Subject: Application for Permit Modification to the Section 404 Individual Permit and Section 401 Water Quality Certification for Construction of extension of NC 43 from south of NC 55 to north of US 17. Craven County. State Project No. 6.804857. TIP No. R-4463. Debit \$570 from WBS 35601.1.1.

The purpose of this letter is to request a modification to the US Army Corps of Engineers (USACE) Section 404 Individual Permit and NC Division of Water Quality (NCDWQ) Section 401 Water Quality Certification. The North Carolina Department of Transportation (NCDOT) is currently constructing the extension of NC 43 from NC 55 to US 17. The project, located west of New Bern in Craven County, is referred to as the NC 43 Connector (Bosch Boulevard) and is approximately 4.5 miles in length. A Section 404 Permit (Action ID 2007-02231-125) was issued on November 19, 2007 and Water Quality Certification issued (WQC No. 3673) on September 21, 2007. The project has been split into two sections, Section A and Section B. Section B has been let and construction has begun.

Summary of Changes

Table 1. Additional Permanent Jurisdictional Impacts for R-4463B

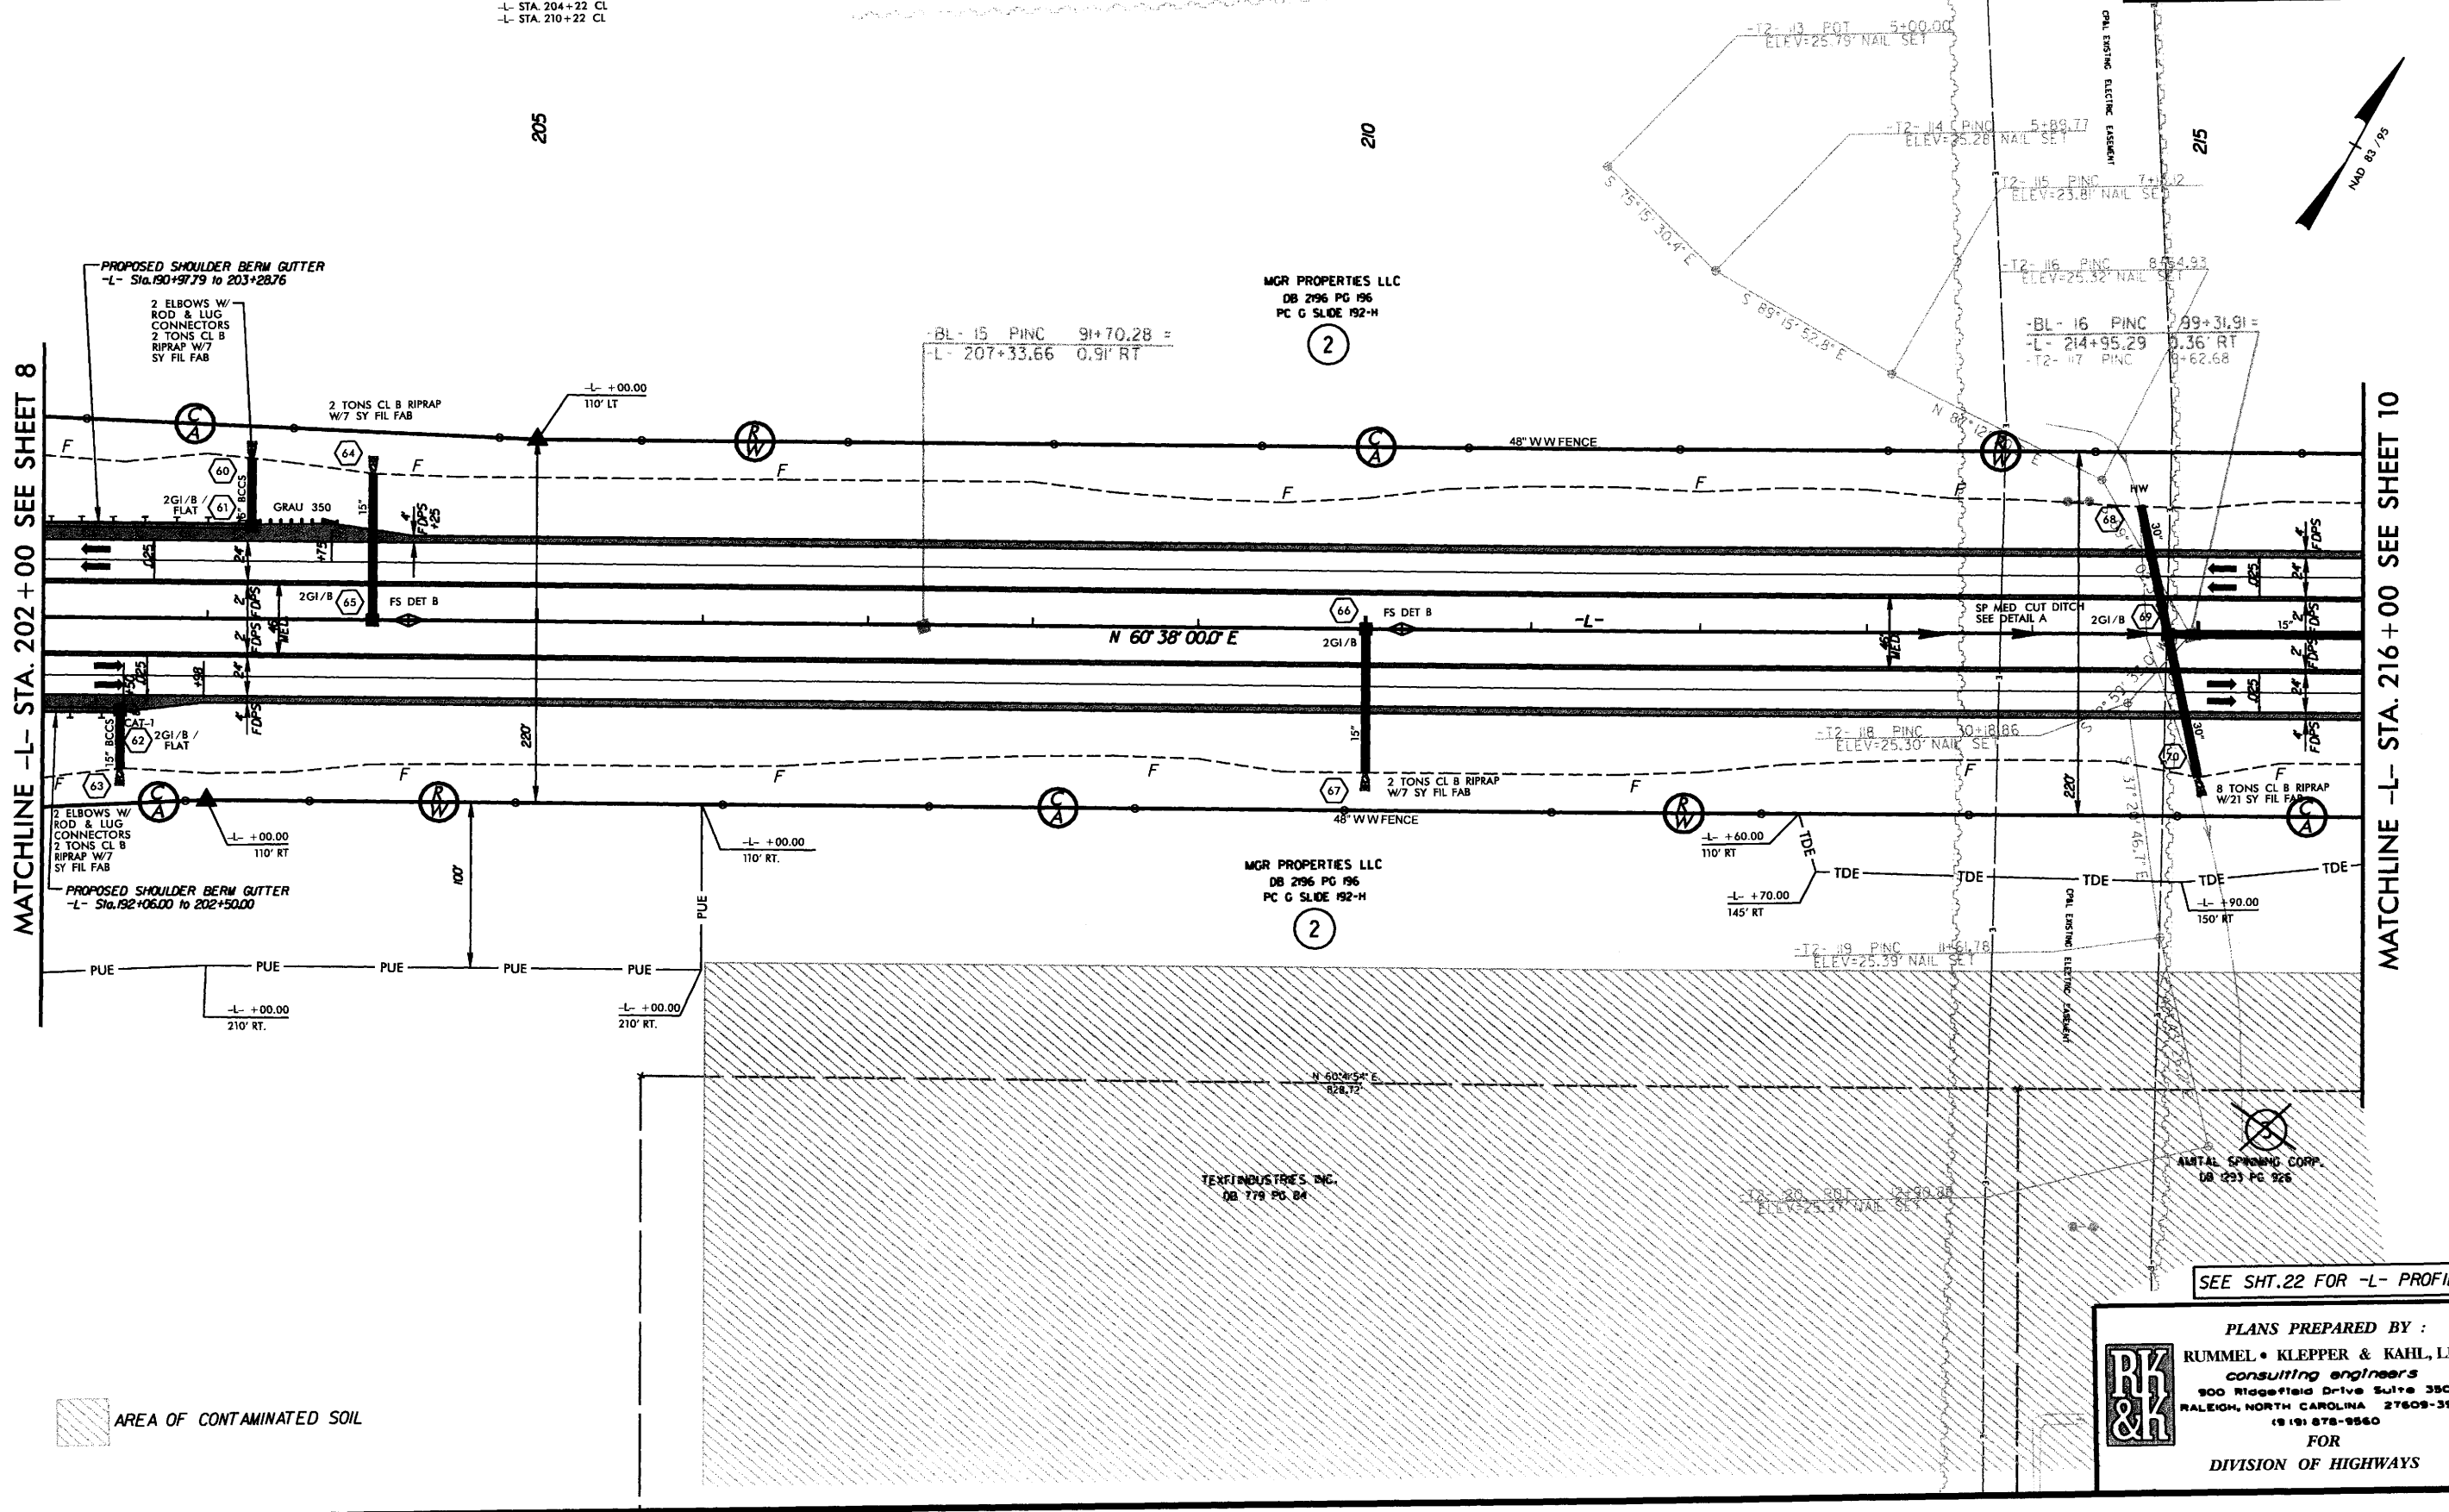
REVISIONS
 Construction Revision #2, Date: _____ Proposed grade revised from -L- Sta. 171+50 to 205+73.15 for new horizontal and vertical clearance criteria for the railroad.

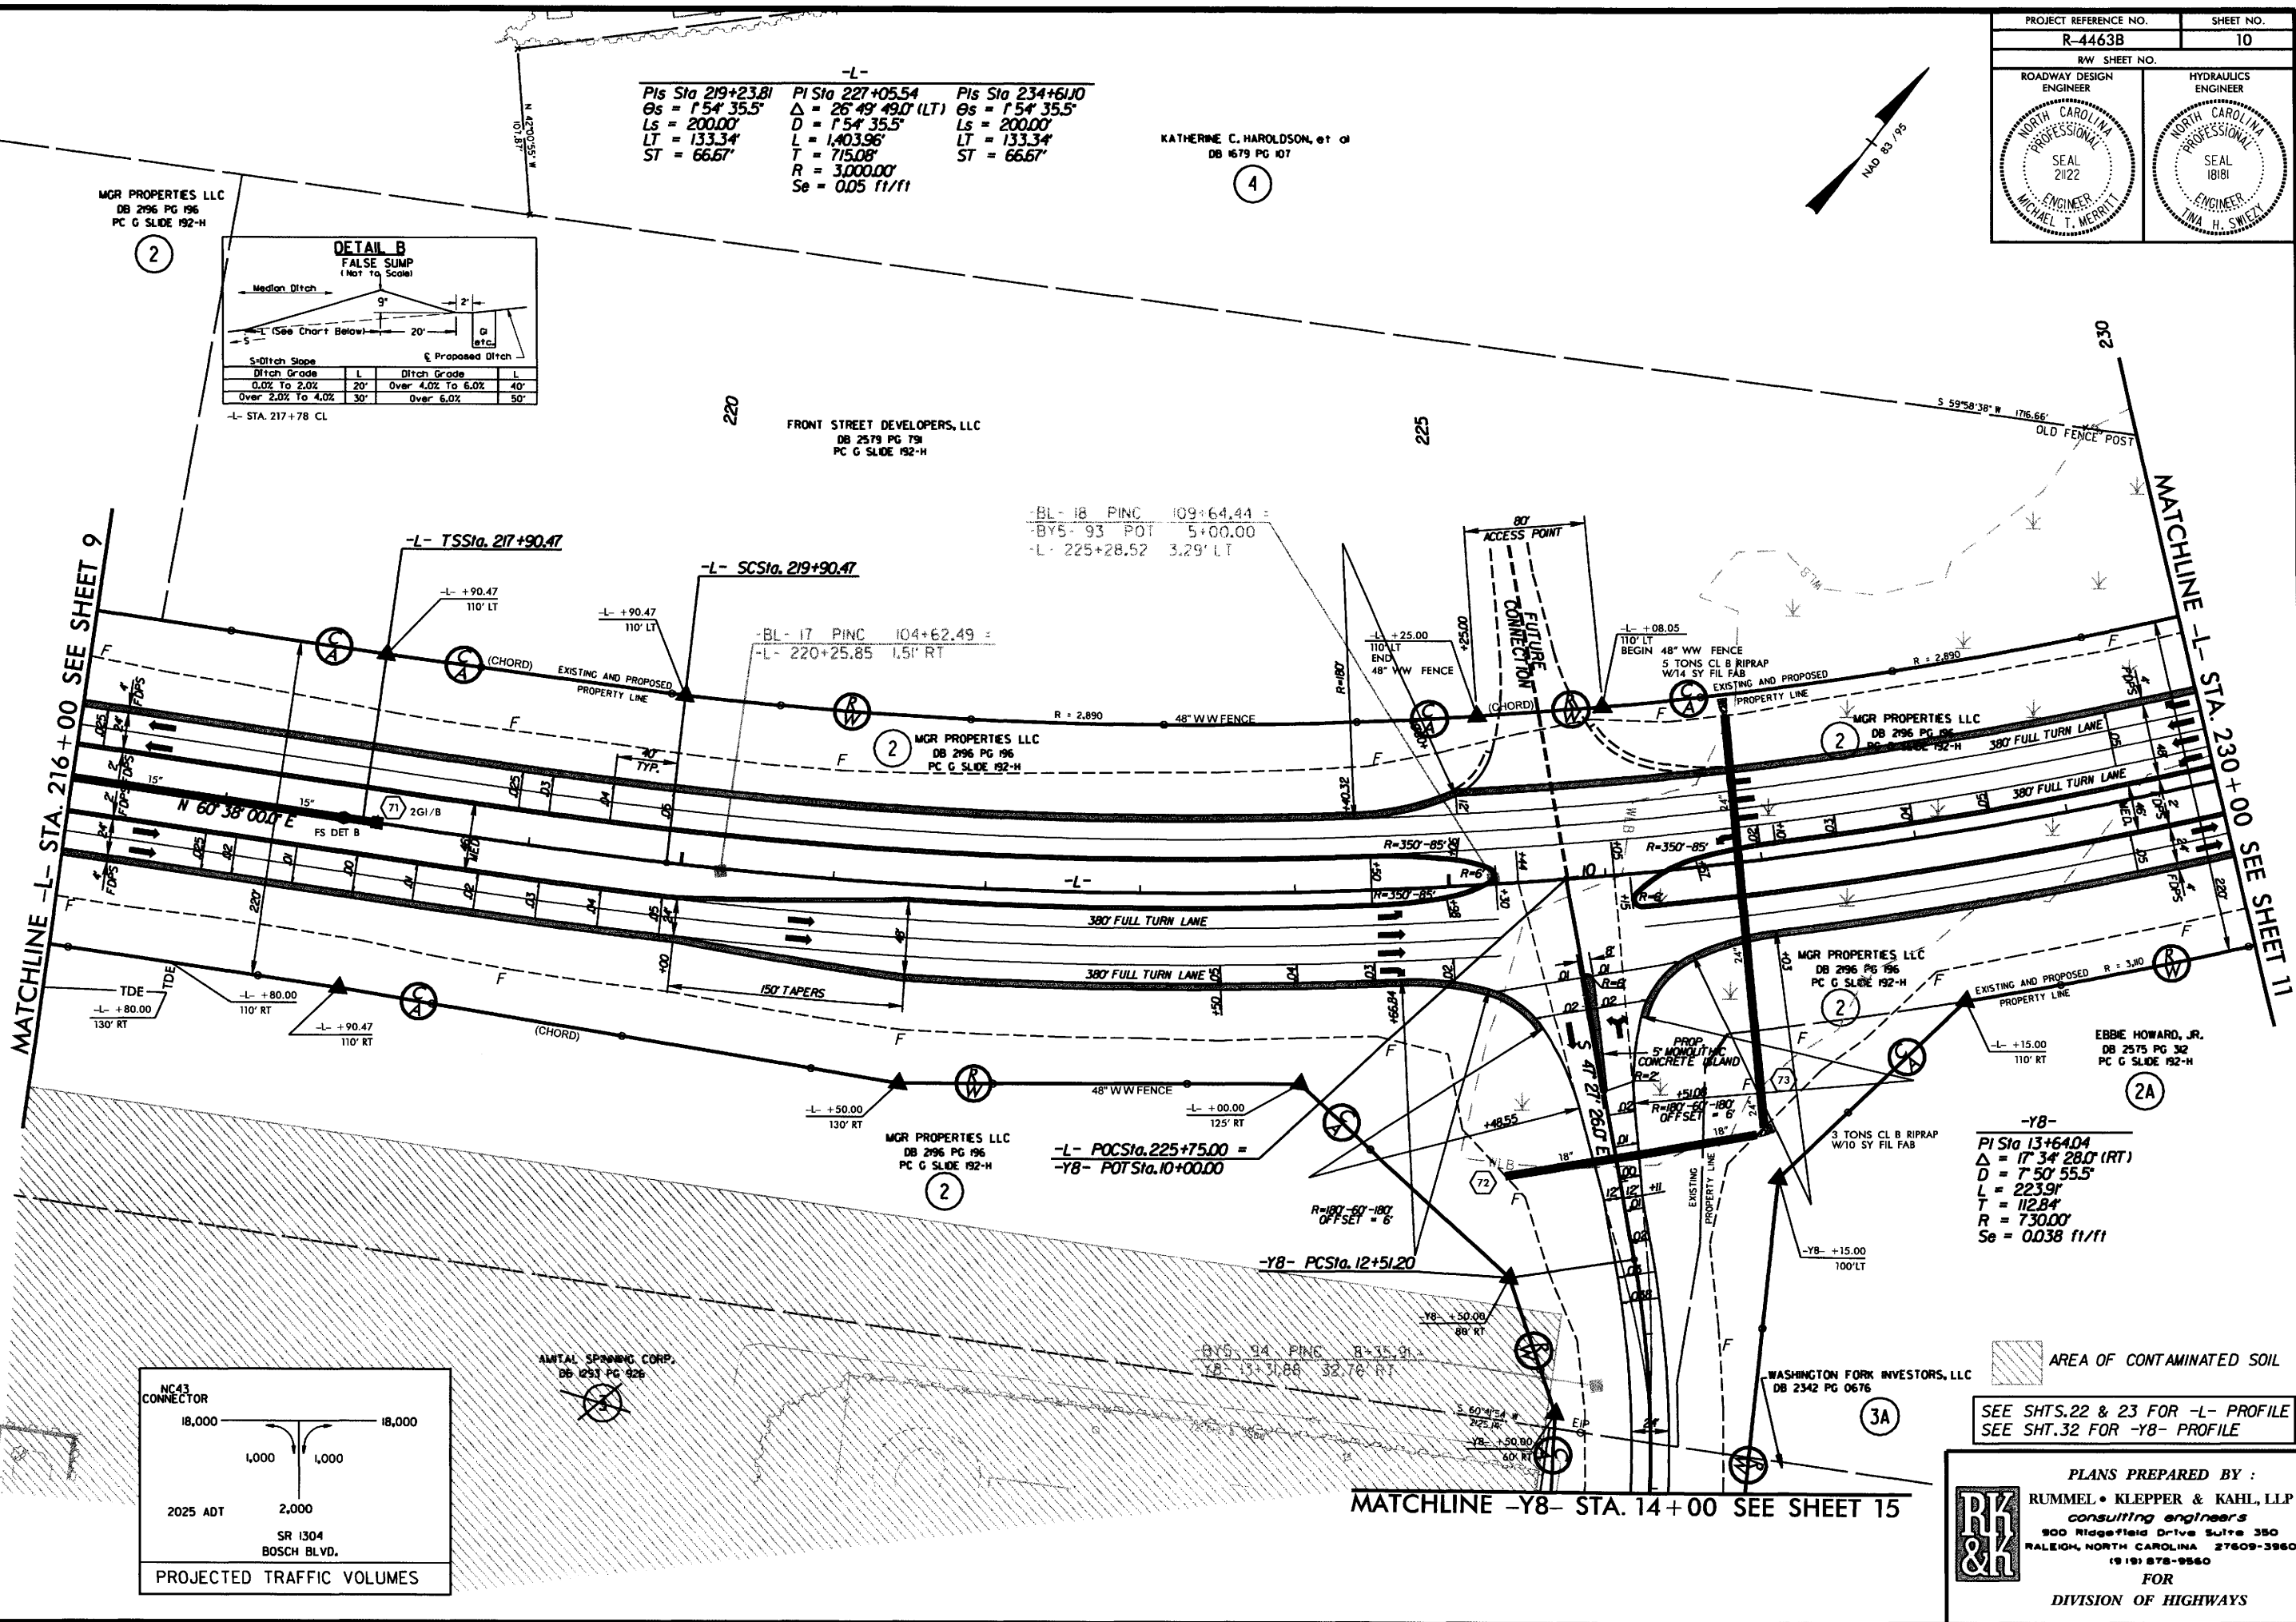
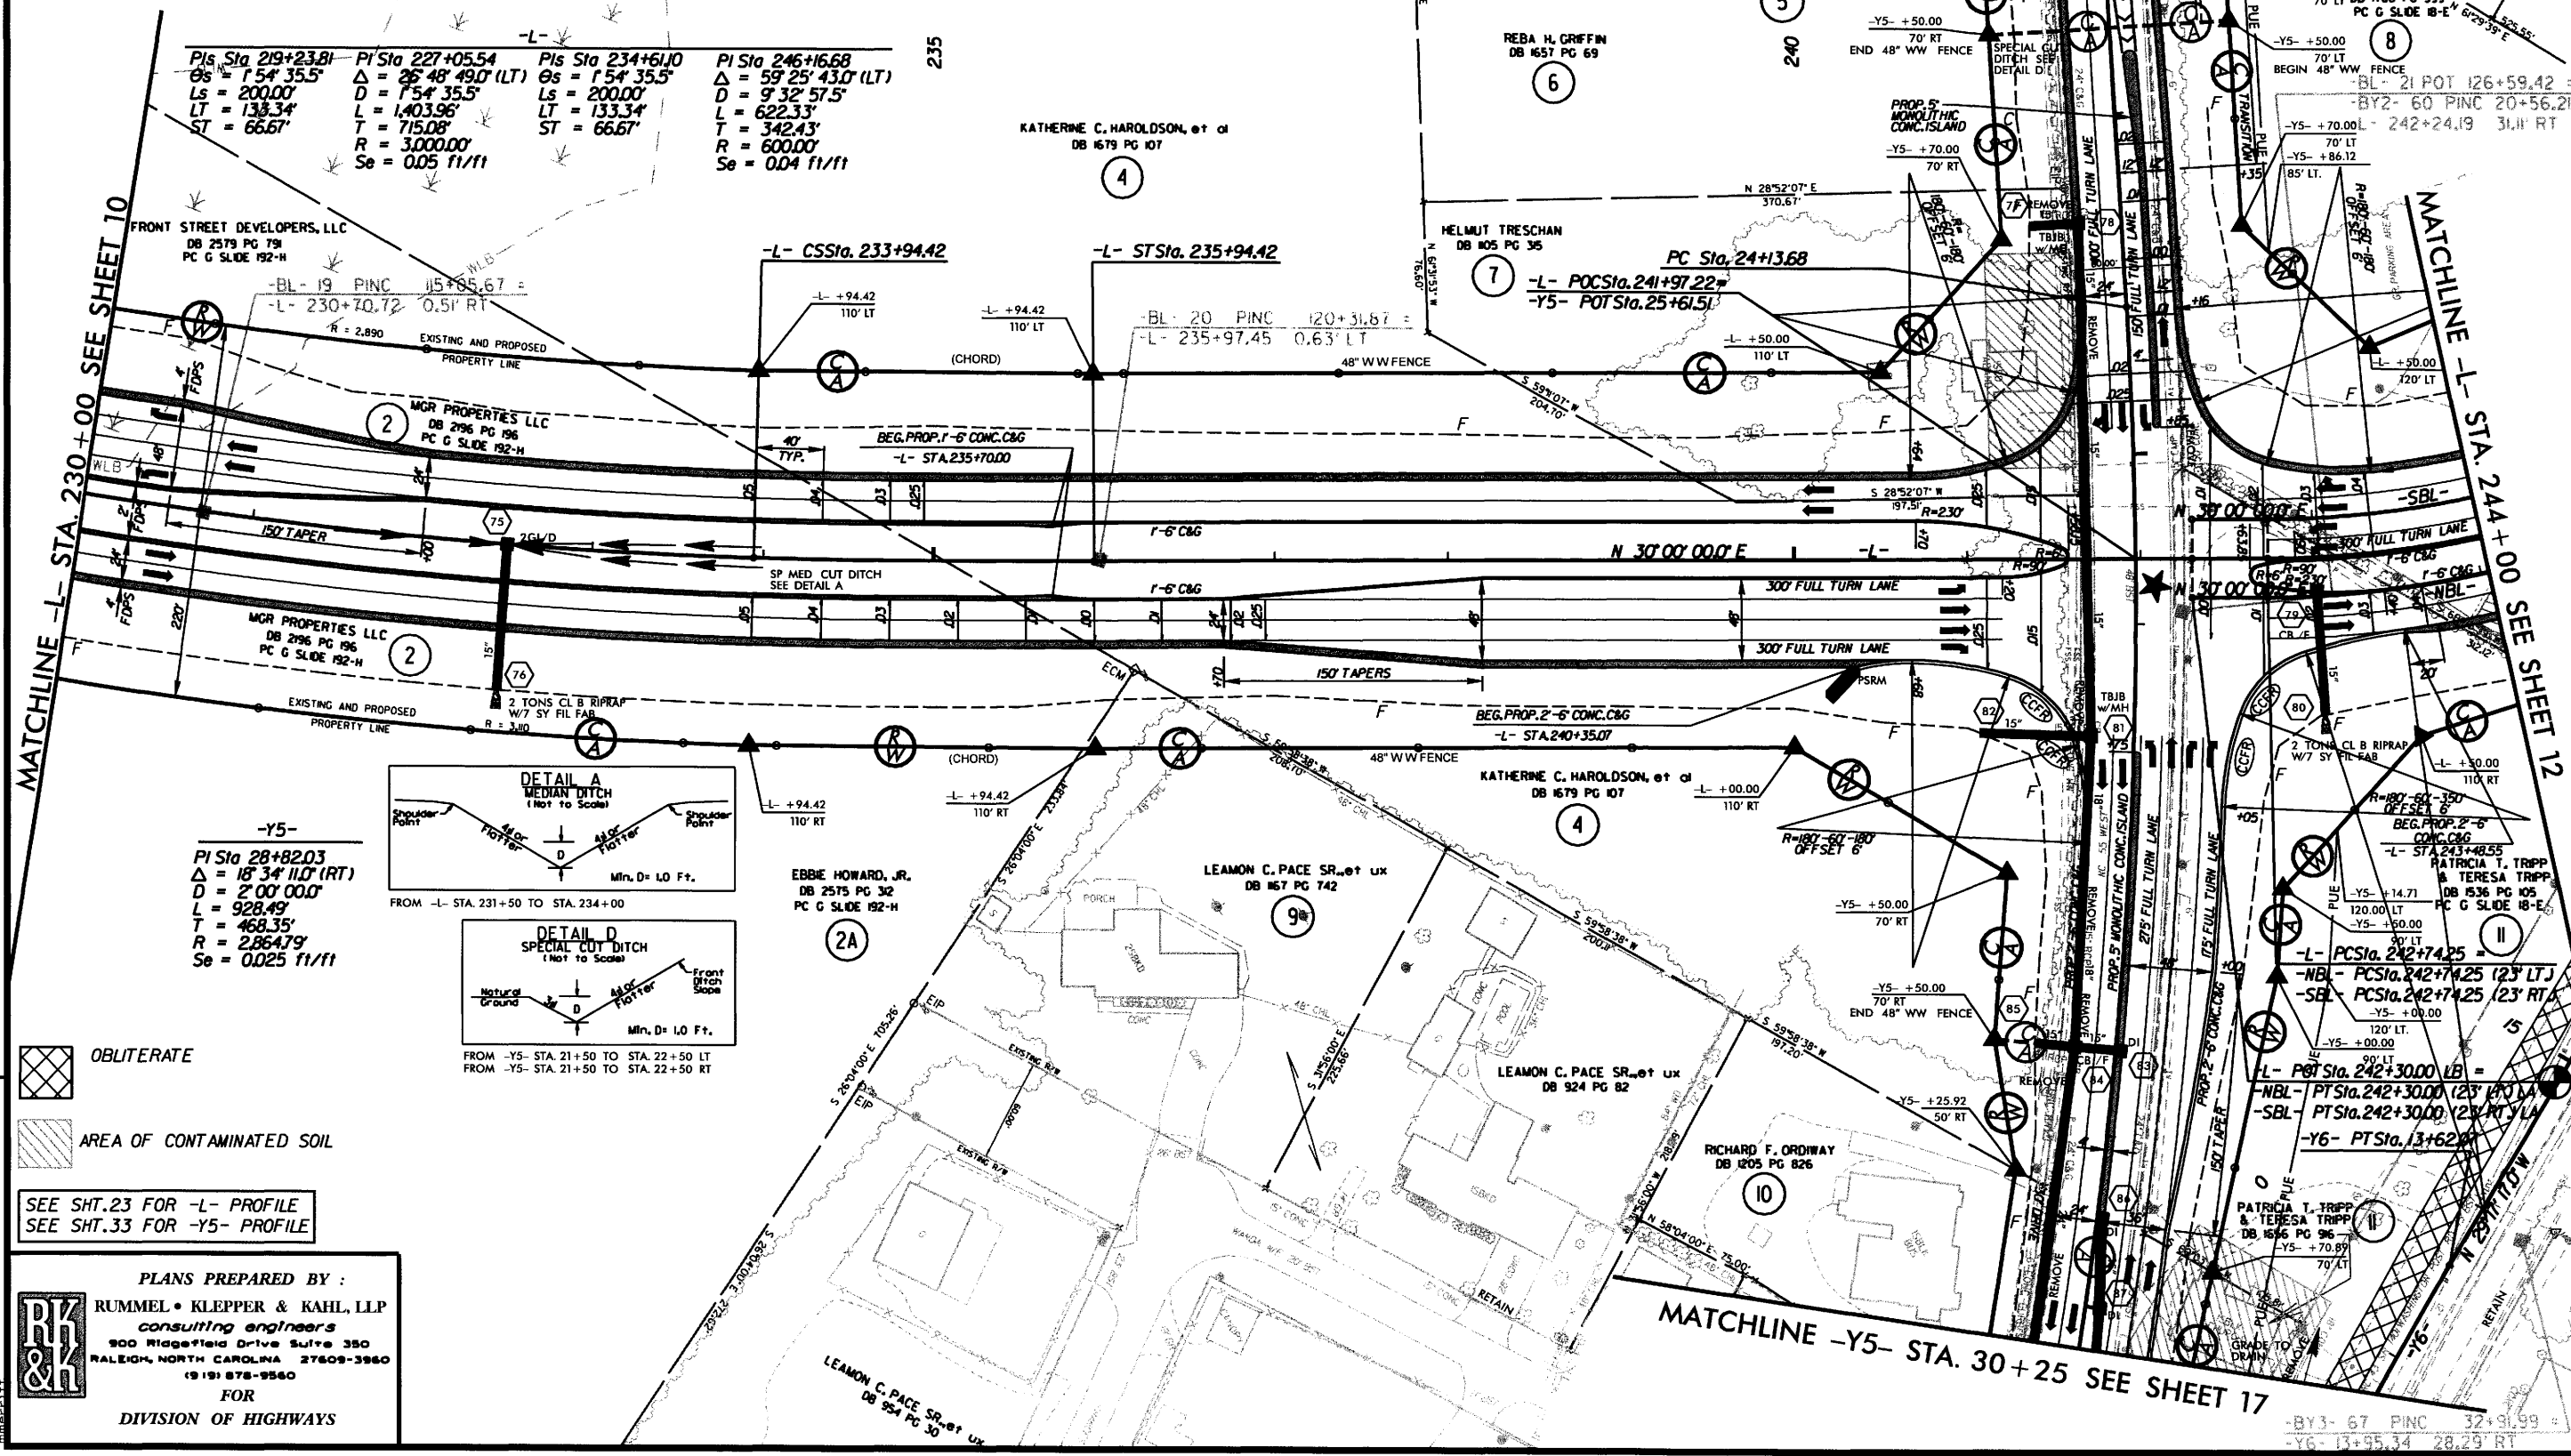
REVISIONS
 Construction revision #2, Date: Added right turn lane opposite -YB-
